Economic Commission for Europe**Inland Transport Committee****World Forum for Harmonization of Vehicle Regulations****159th session**

**1958 Agreement – Consideration of draft amendments
to existing Regulations submitted by GRE****Proposal for Supplement 17 to the original version of
Regulation No. 87 (Daytime running lamps)****Submitted by the Working Party on Lighting and Light Signalling***

Figure 1a

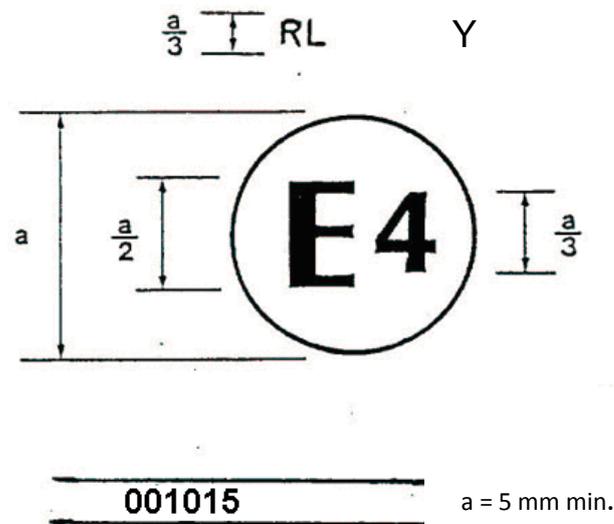
Annex 2, Insert new example of the approval mark, to read (the amendment is marked in RED):

The lamp bearing the approval mark shown above has been approved in the Netherlands (E4) under number 001015 as a part of an interdependent lamp system composing a daytime running lamp. The approval number indicates that the approval was granted according to the requirements of this Regulation in its original (un-amended) form. "
